ATTACHMENT 5

Letter from M. E. Warner (NMC)

License Amendment Request 187

Revised Pages for Updated Safety Analysis Report
(USAR)

Figure 14.1.8-8

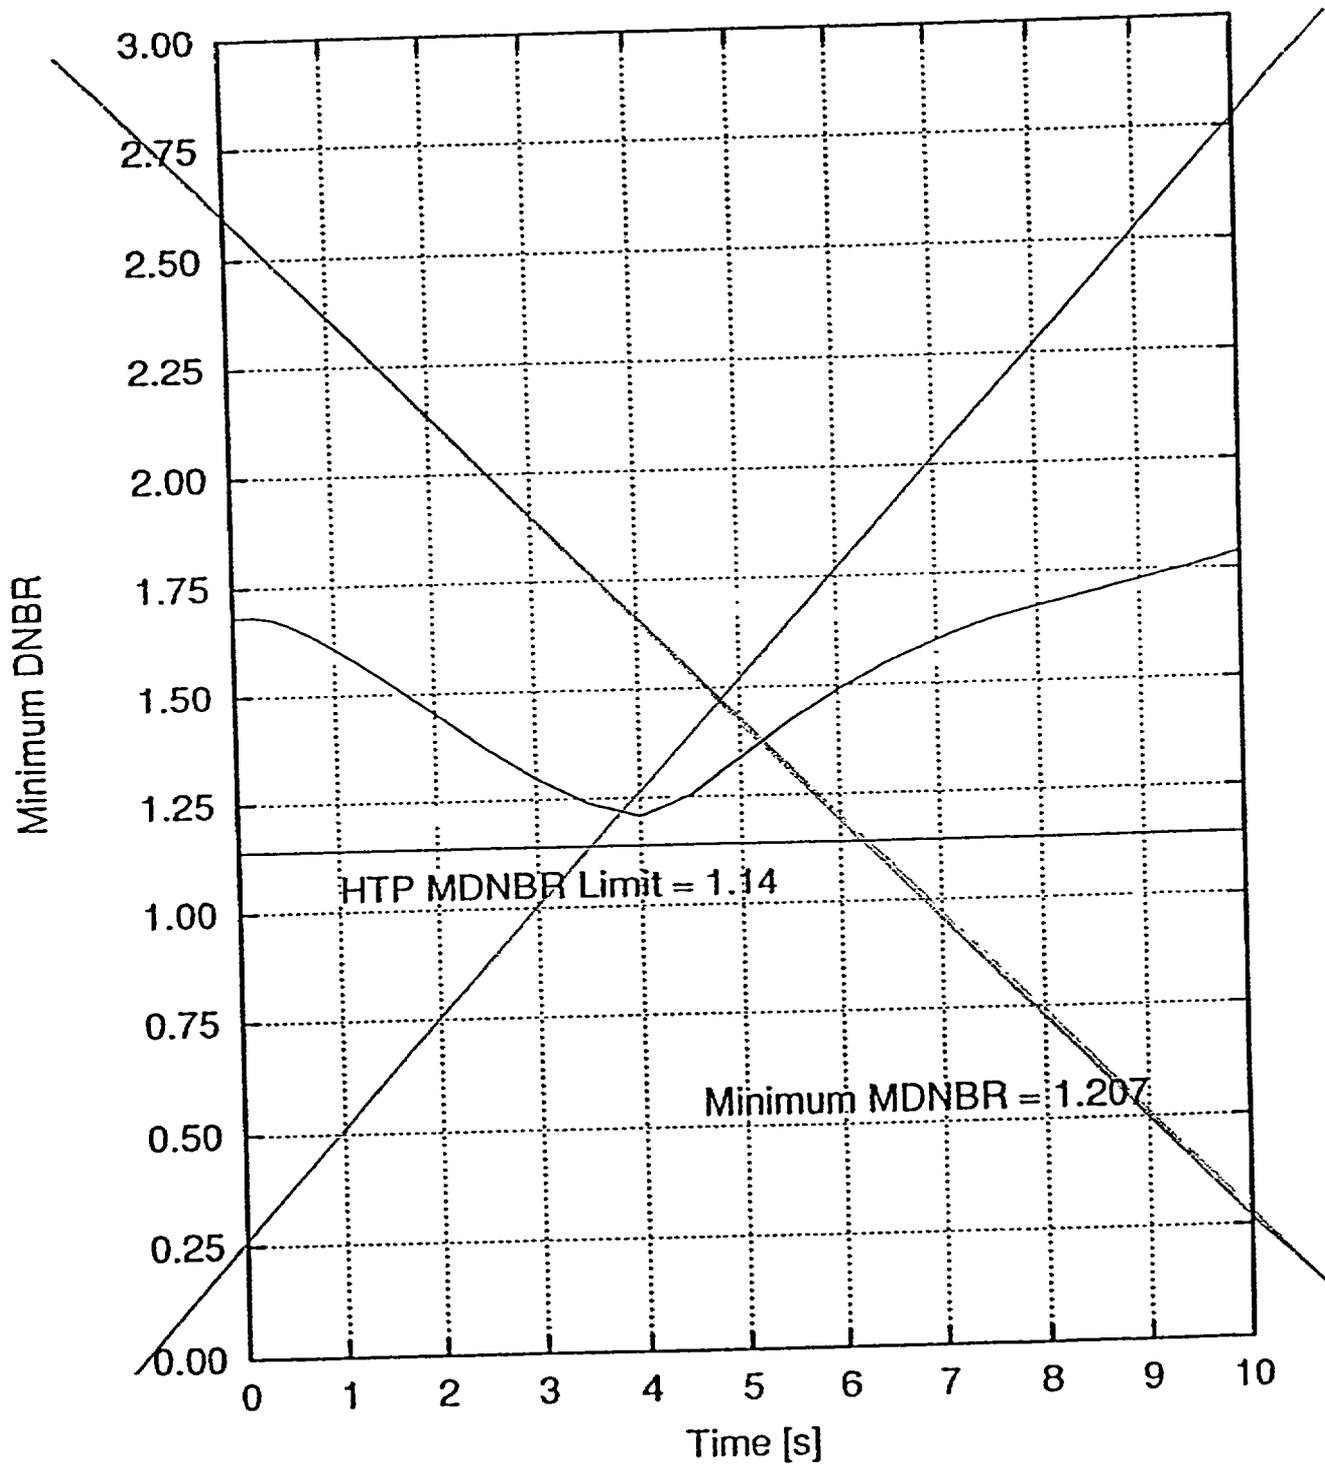
REPLACE WITH NEW FIGURE 14.1.8-8

Figure 14.1.8-9

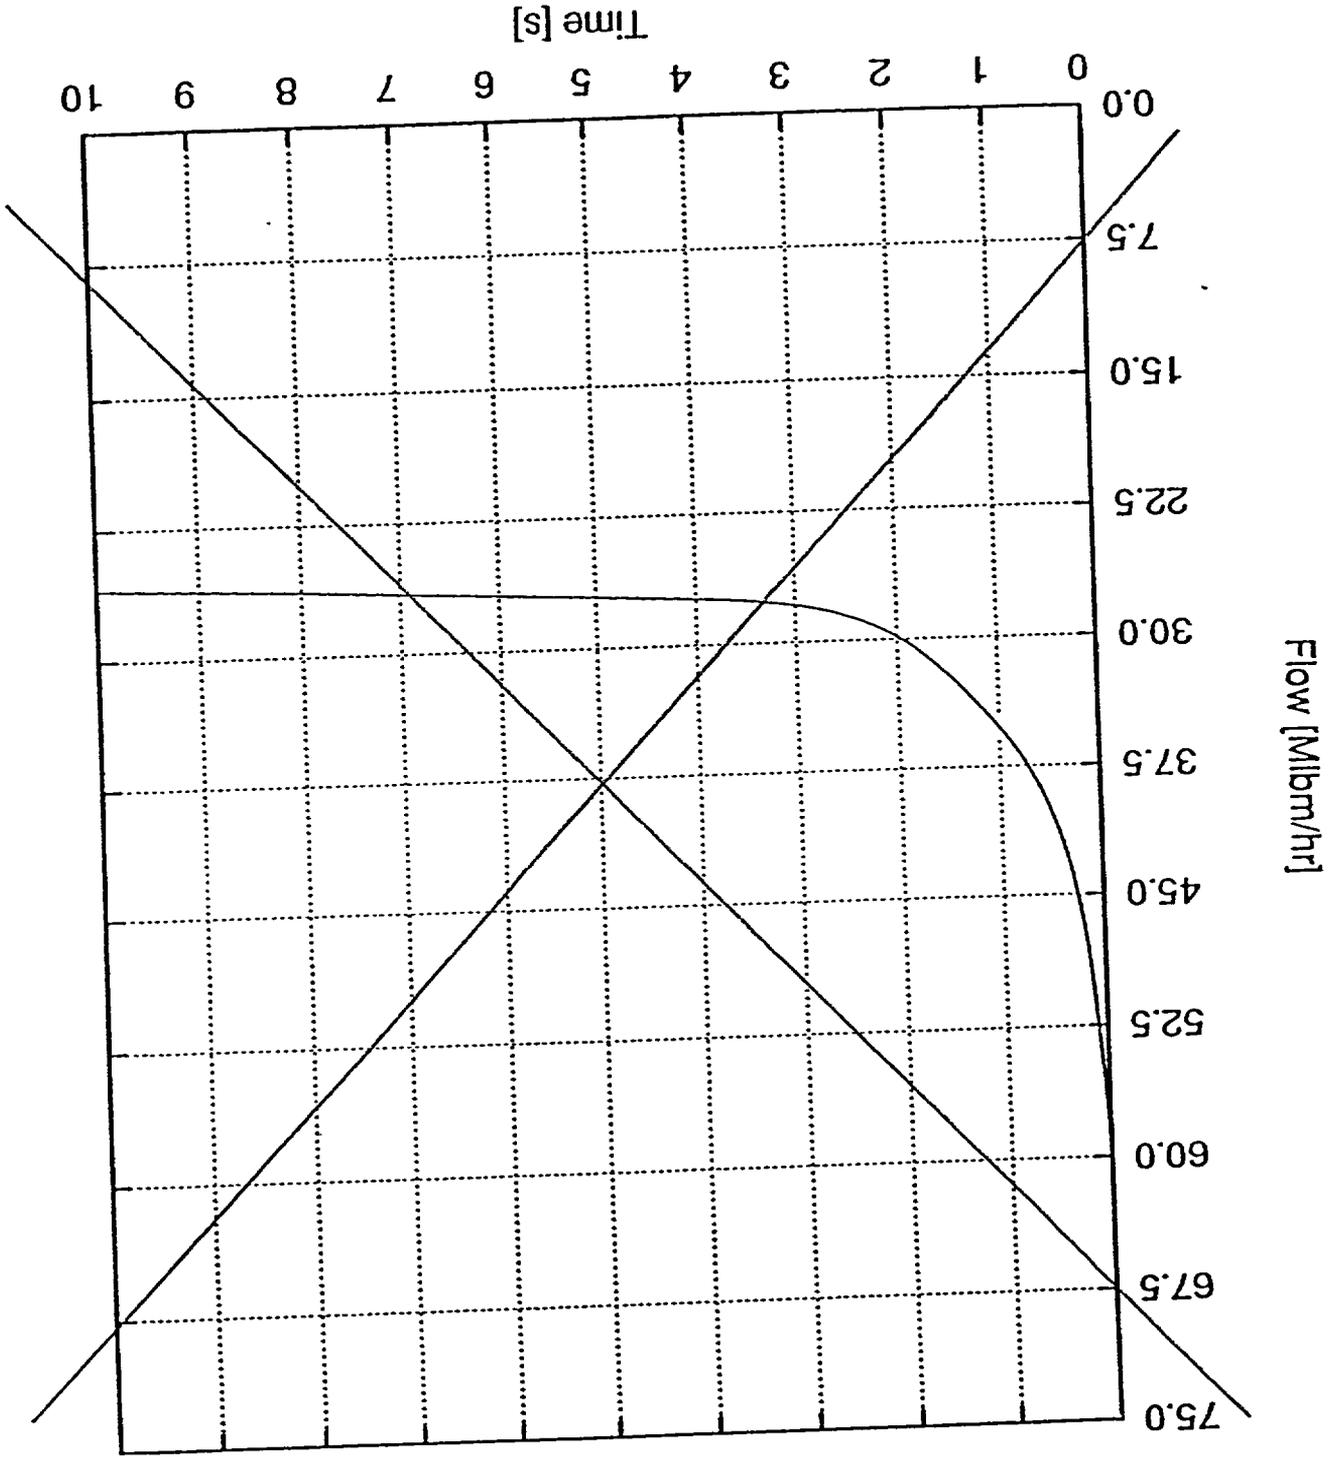
REPLACE WITH NEW FIGURE 14.1.8-9

Figure 14.1.8-10

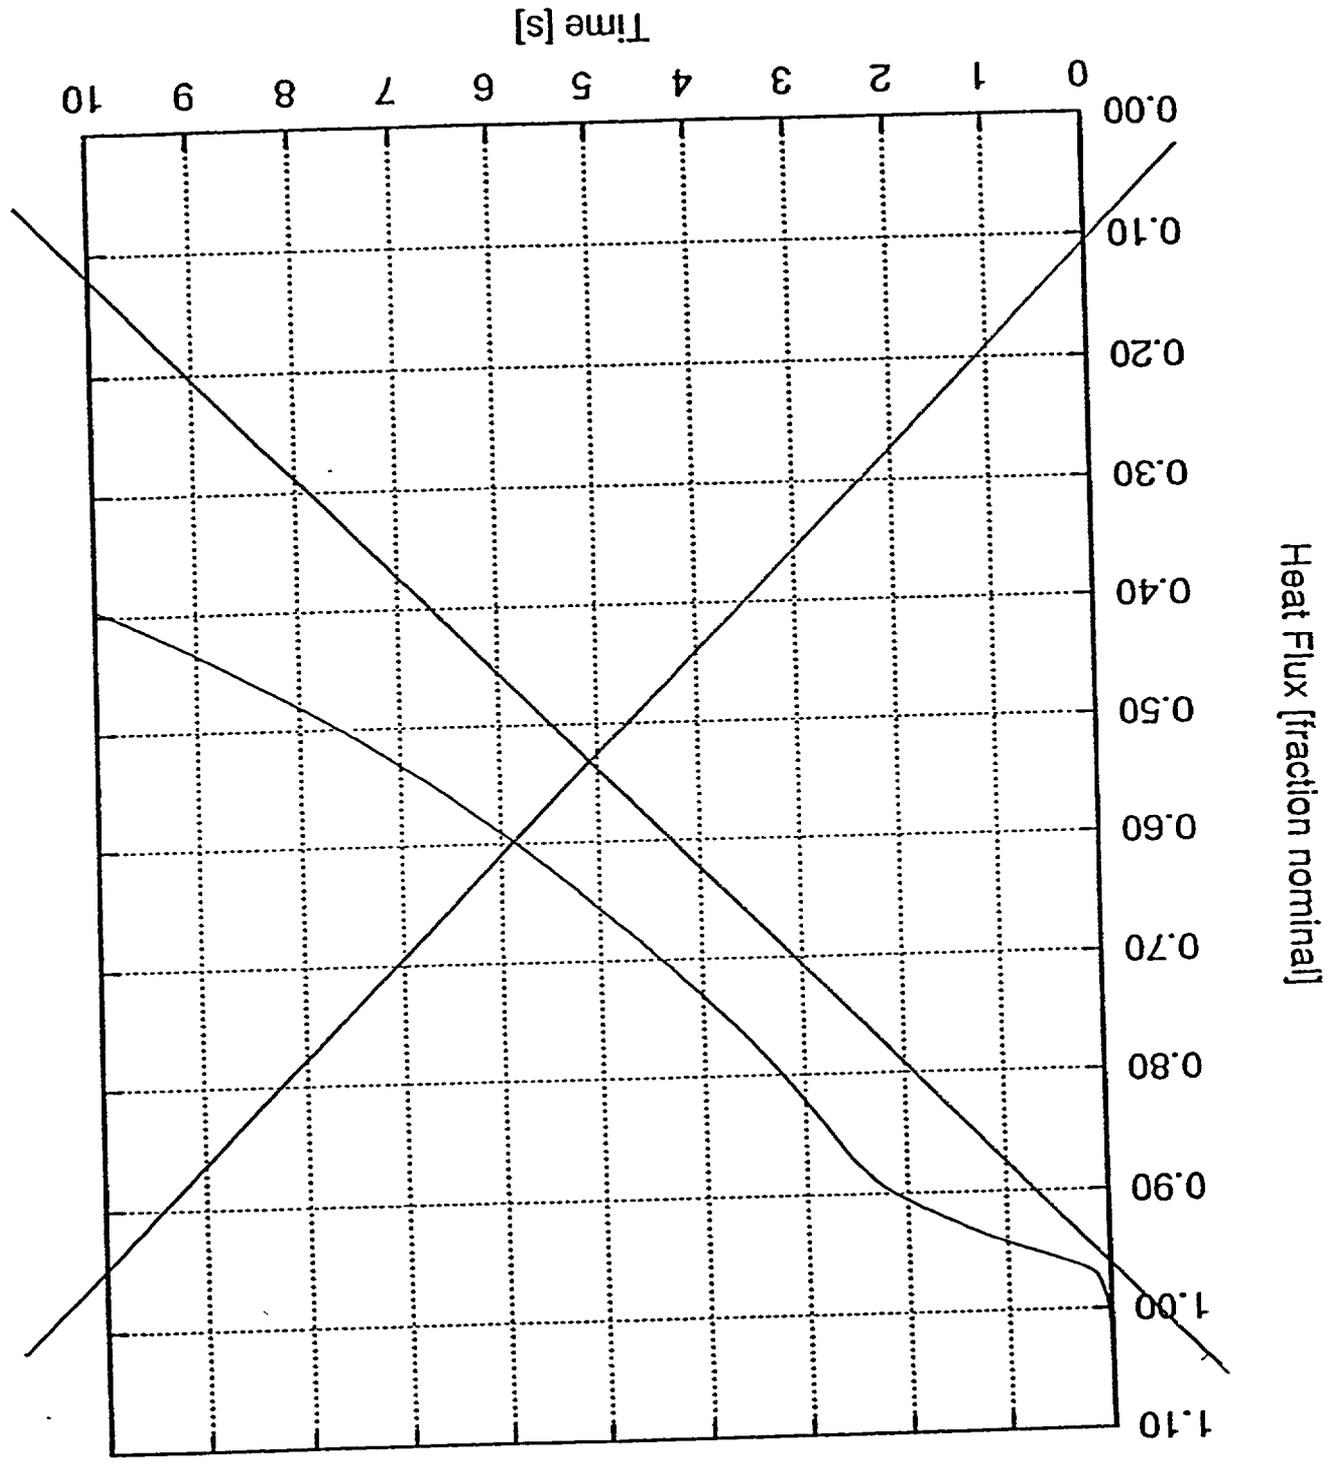
REPLACE WITH NEW FIGURE 14.1.8-10

Figure 14.1.8-11

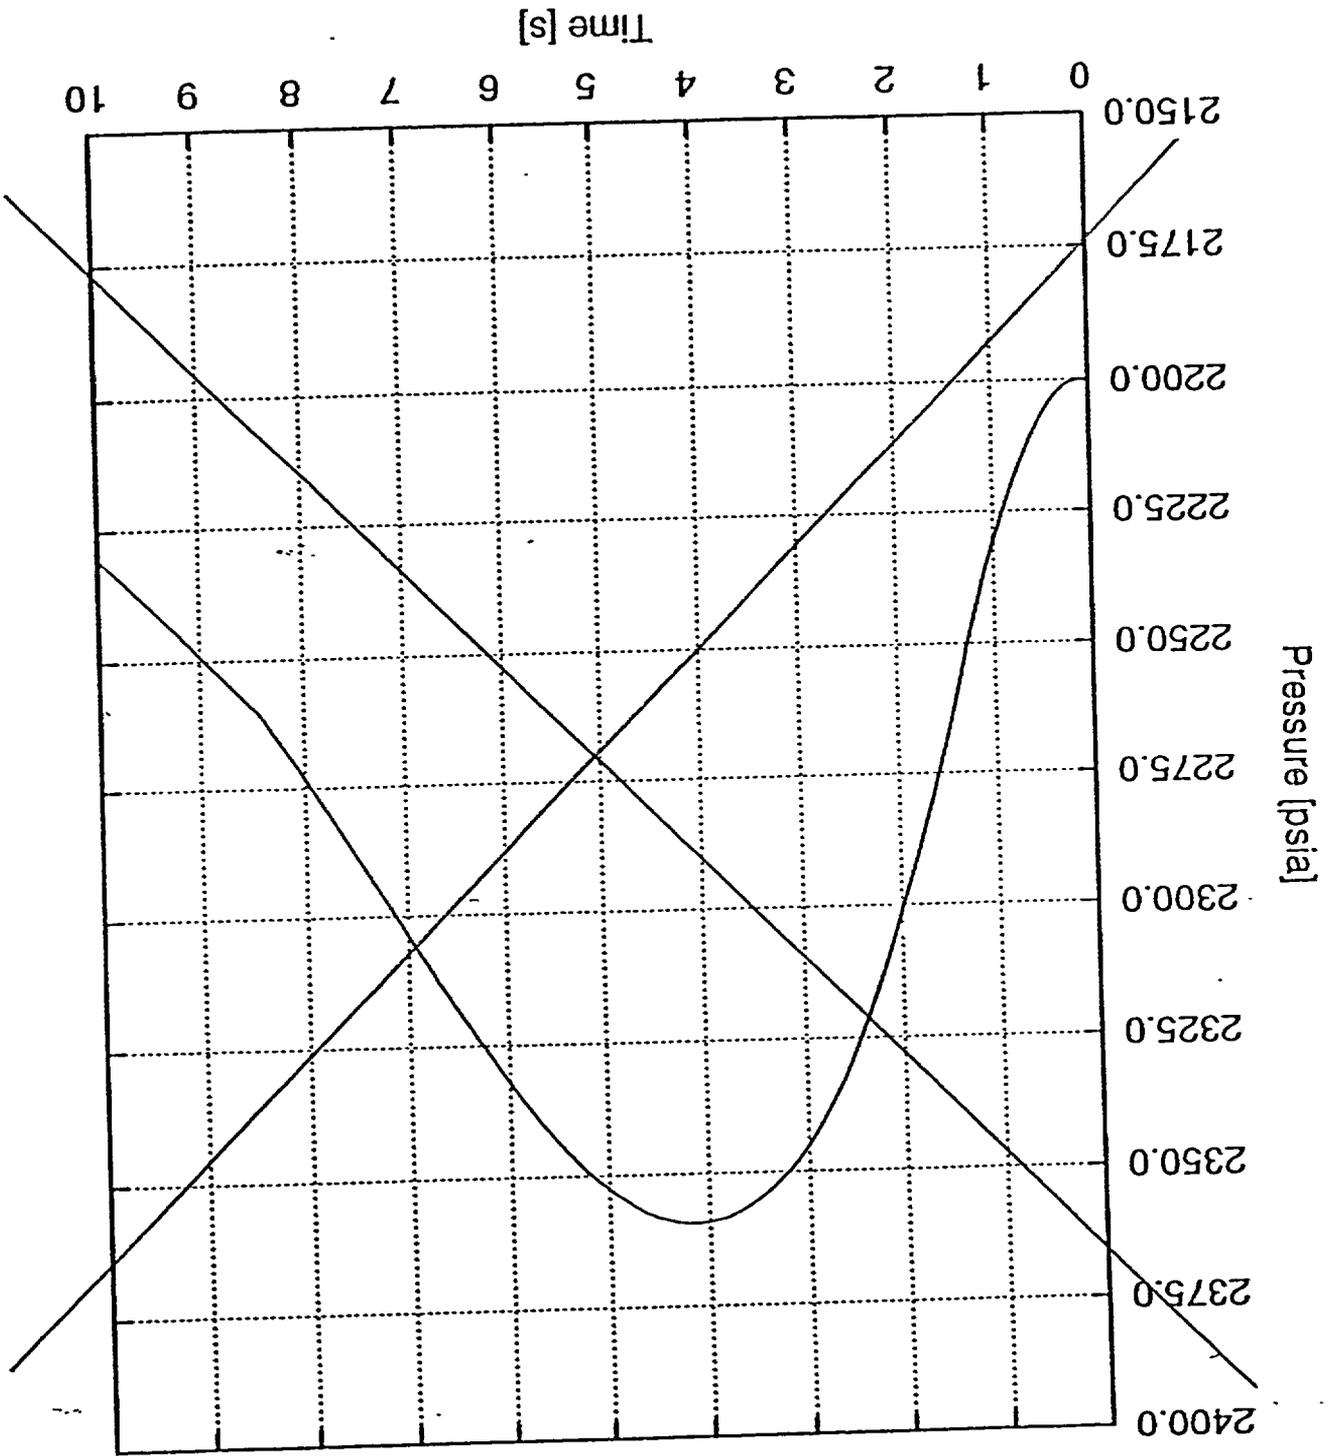
REPLACE WITH NEW FIGURE 14.1.8-11

Figure 14.1.8-12

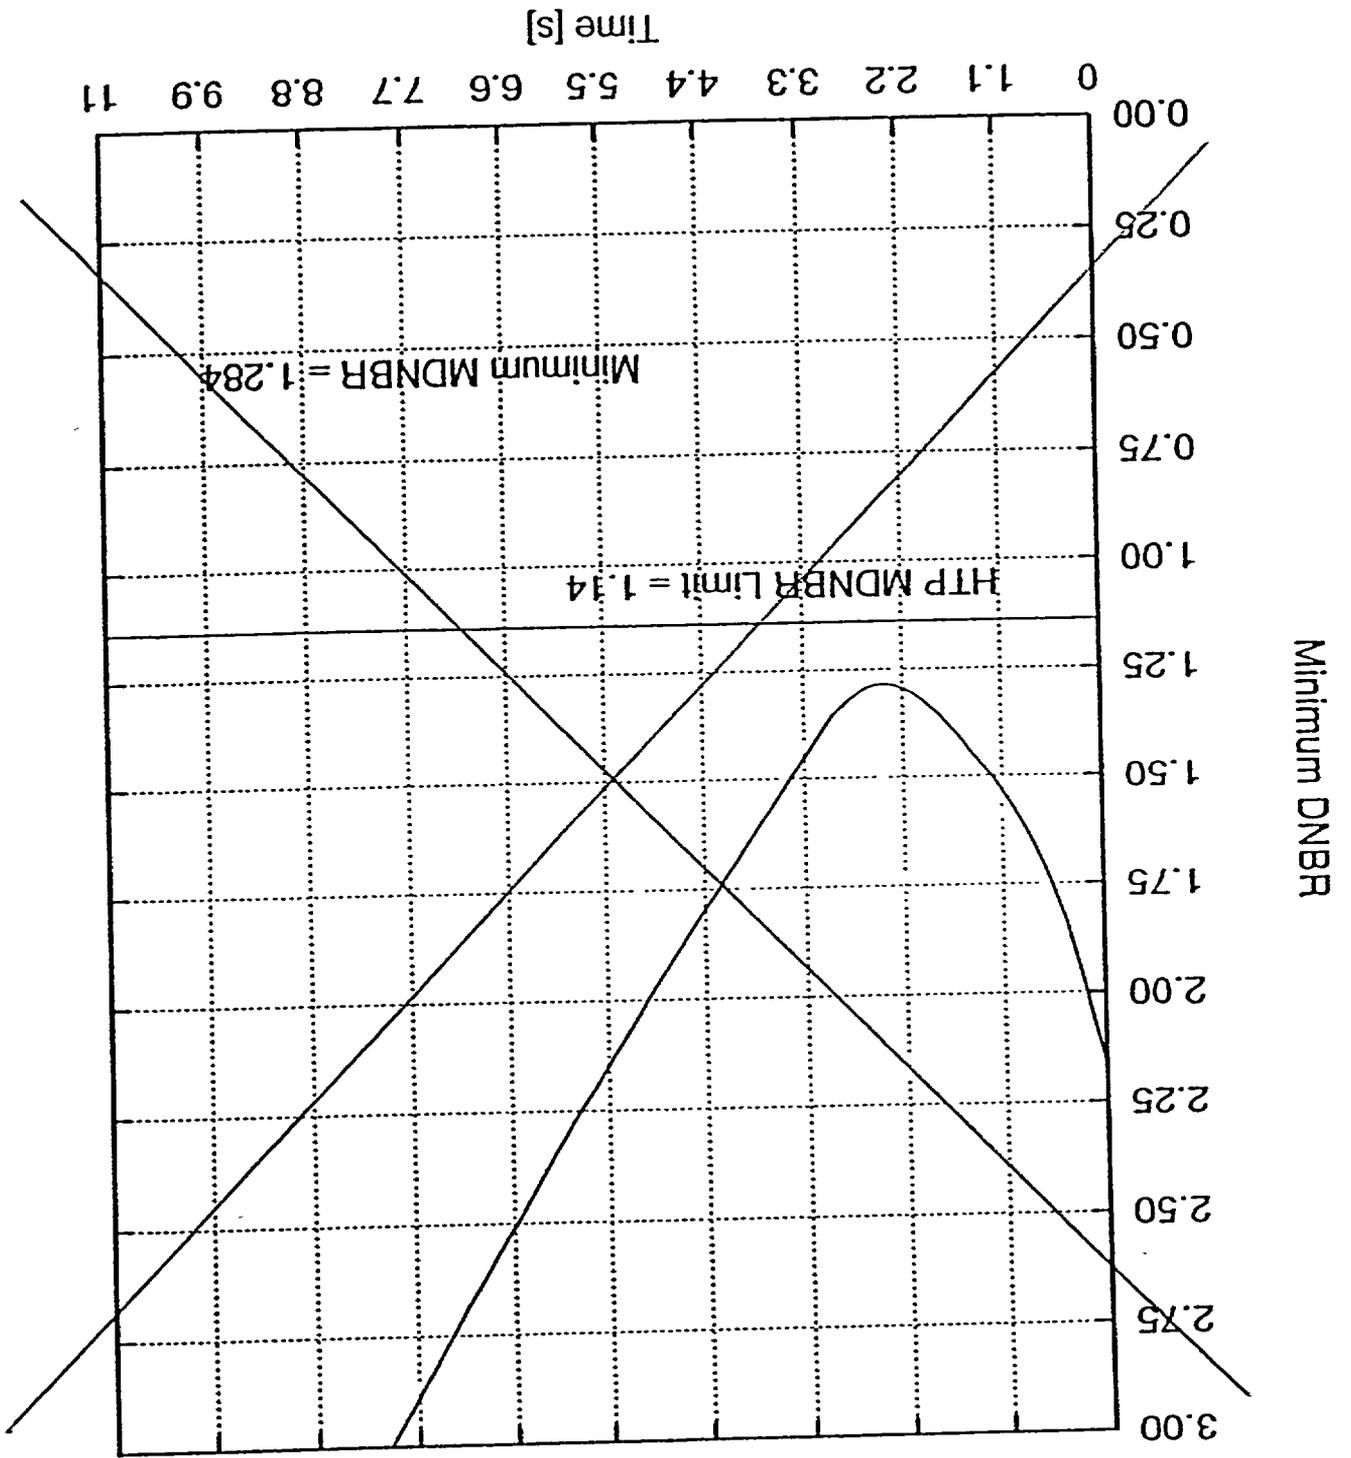
REPLACE WITH NEW FIGURE 14.1.8-12
